# C2M CDAUI-8: considerations and proposals on P802.3bs 400 Gb/s Ethernet draft.

- P802.3bs 400 Gb/s Ethernet Draft 1.0 under review.
- This presentation refers also to some comments submitted by G.Nicholl (#185), P. Tooyserkani (#187, #188) and J.Maki (#191, #192)

# 1 – Improve Reference RX equalizer: from [mazzini\\_01\\_082415\\_elect](#) (Mazzini, Brooks, Reddy Kareti) and further work (Brooks).

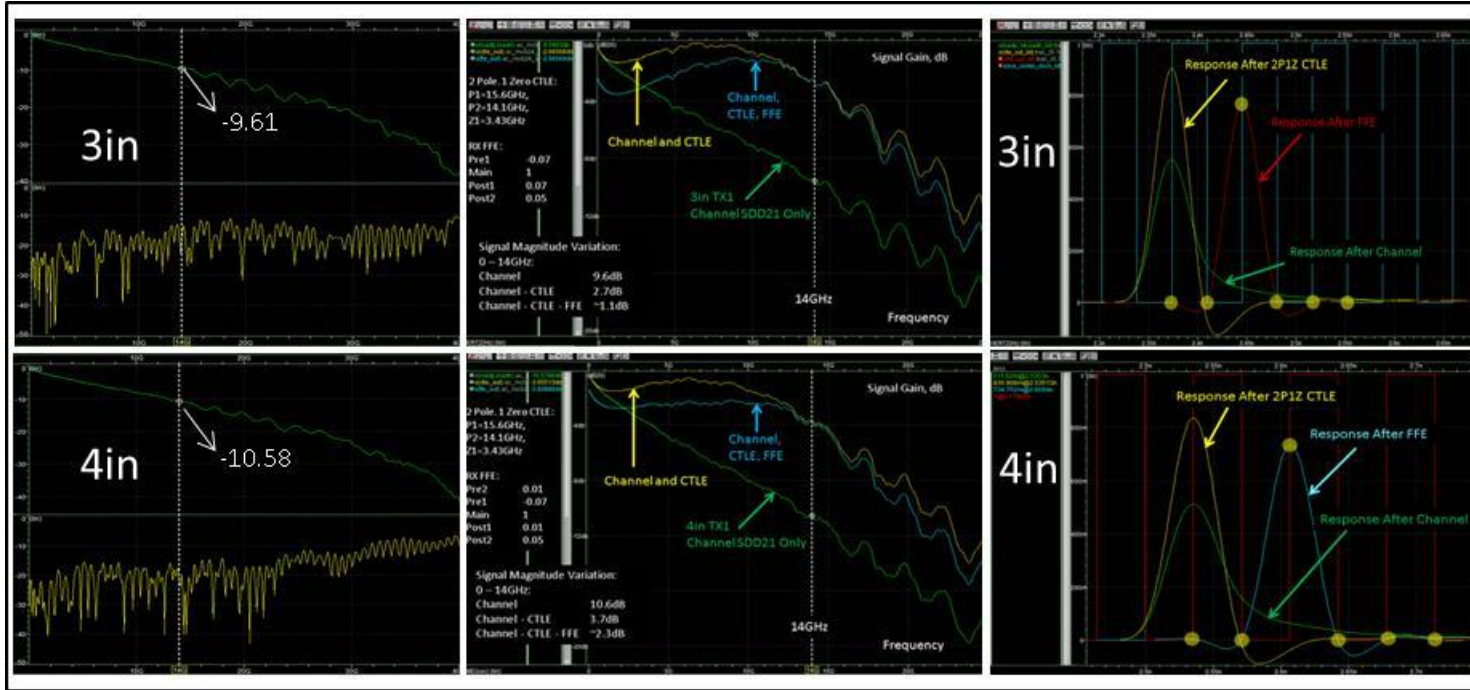
Further work done over these new channels still showing that there's the need to improve Draft 1.0 RX reference equalizer.

**Both experiments and simulations shown 2p1z module's RX CTLE it's not enough to close the link at 1E-6 BER.**

- **Simulation showing that even a 3p2z RX CTLE equalizer can be tight for 1E-6 BER requirements.**
- **The PAM-4 EQ is much more critical than NRZ for the same symbol time.**
  - **Adjacent Eyes → Very Little Over or Under EQ Allowed!**
  - **Channel variations: worse impact than NRZ → Need of slow (but continuous) adaptation.**

# 1 – Improve Reference RX equalizer: from [mazzini 01\\_082415\\_elect](#) (Mazzini, Brooks, Reddy Kareti) and further work (Brooks).

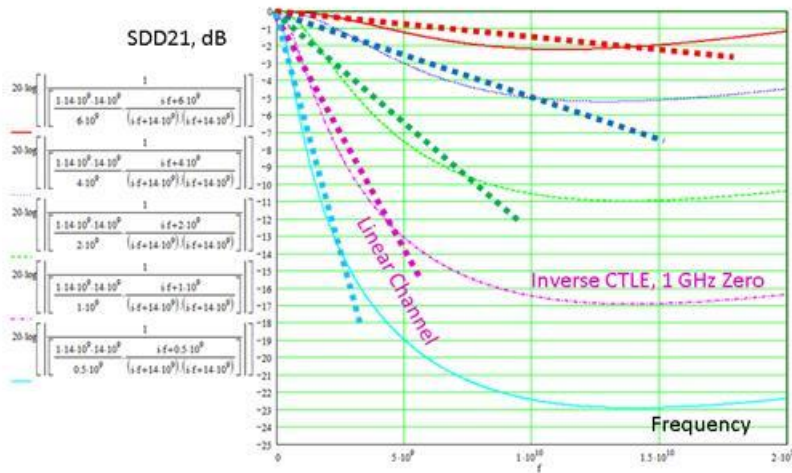
2p1z CTLE seems not enough to ensure the correct target BER over any of the QSFP28 card tested cases.

- Channels are Roughly Linear on a dB vs Linear Frequency Plot.
- With CTLE Alone, Channels can be Equalized only up to a certain frequency.

Adding Low Frequency De-emphasis Filter to Generic RX Model

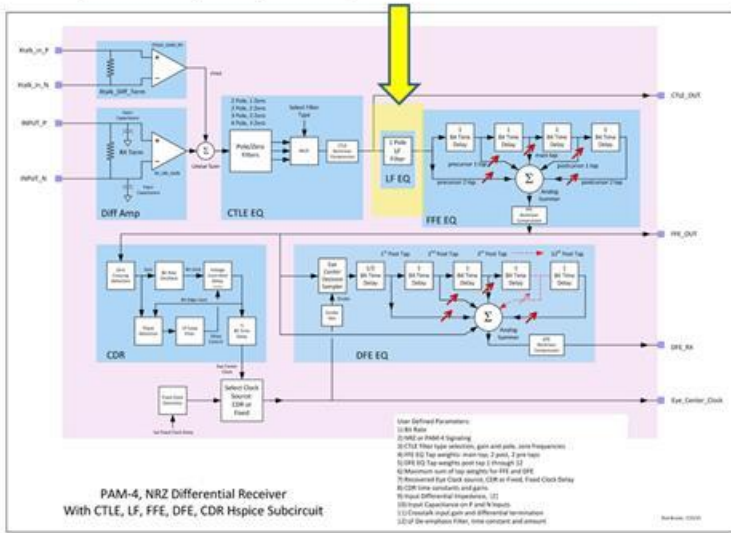
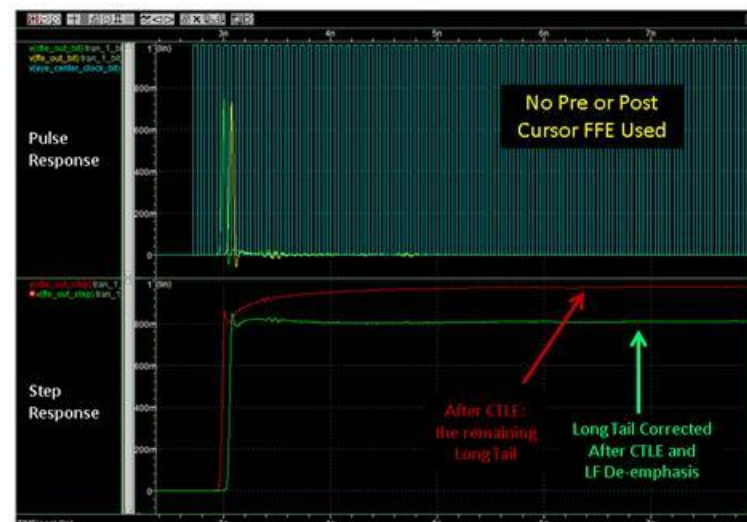
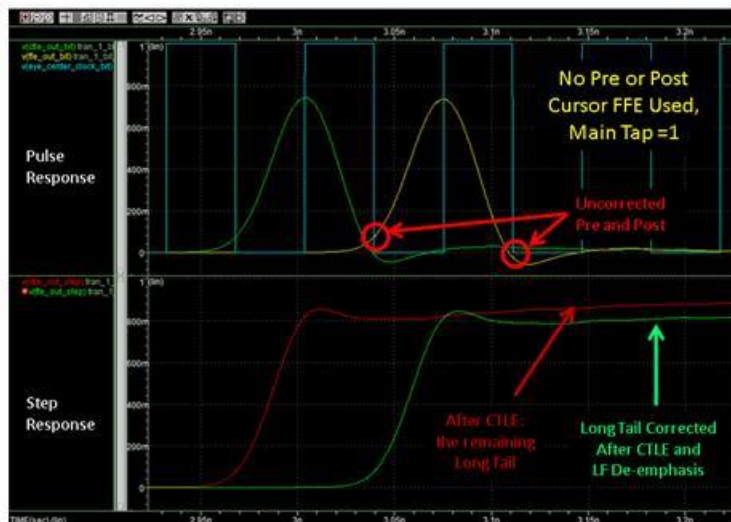
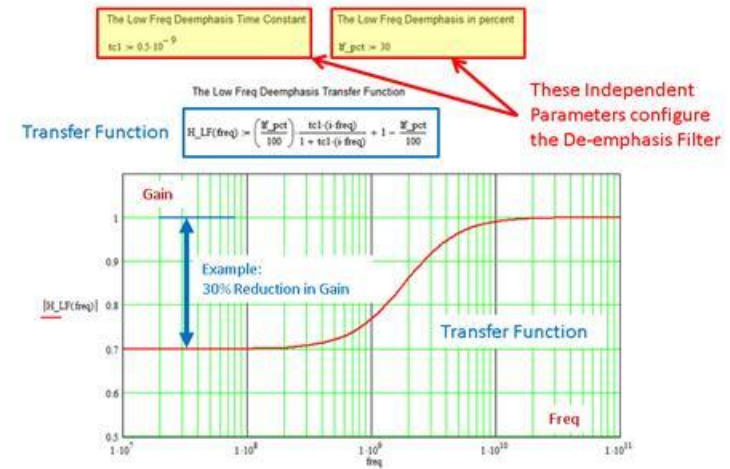
- Benefit of adding a Low Frequency De-emphasis Filter to Correct the Step Response  
Best Case: No RJ, DJ, Noise, Crosstalk.
- **A Low Frequency filter is needed to help equalize long data patterns.**
  - **LF time constant: 0.1ns to 0.5ns for C2M**
  - **LF De-emphasis amount: 0 to 25% for C2M**

- (Items 1-2) Improve Reference receiver: Draft 1.0 CTLE (2p1z) + LFEQ (1p1z, divided by xx).
  - We are open to agree the frequency range of the LF filter based on contributions.
- (Item 3) Verify if possible to relax BER requirement from 1E-6 to 1E-5.
- (Item 4) Define an informative minimum TP0a SNDR of 29dB (TP0a only measurable point).
- Introduce a channel ILD deviation (#187,#188) mask requirement or limit ILD value – we propose 0.25dB<sub>rms</sub> (further validation is needed).
- (Item 4) Allow an optional (not mandatory) “fixed and universal” TX FIR.

# - Improve CDAUI-8 C2M test – Define Vertical eye closure (VEC) at TP1a.

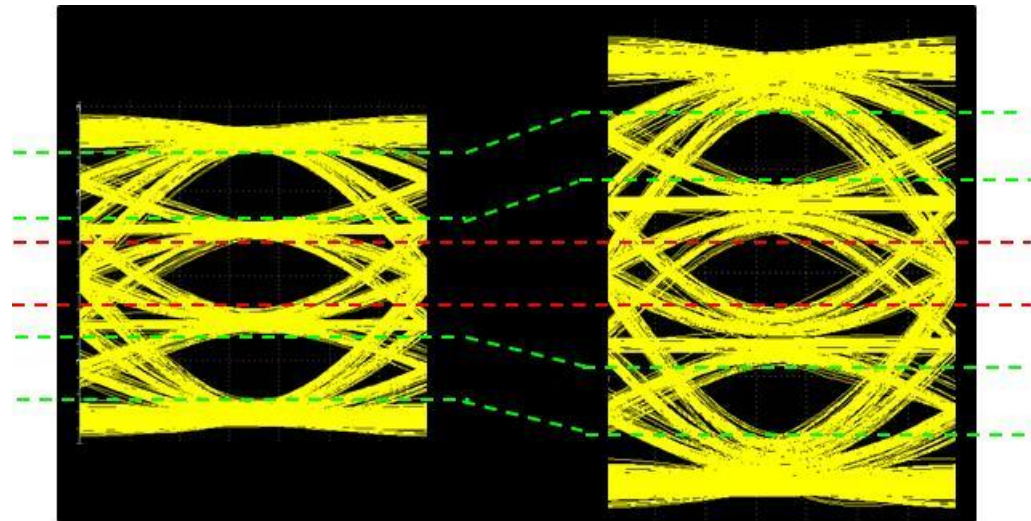
Same EW, EH can be achieved with different VEC at TP1a.

Define a maximum VEC at TP1a too would help to constrain host output and calibrate the TP1 input stressor to the CDAUI-8 module.

- (slide 12) Include TP1a VEC requirement.
  - Value to be agreed.
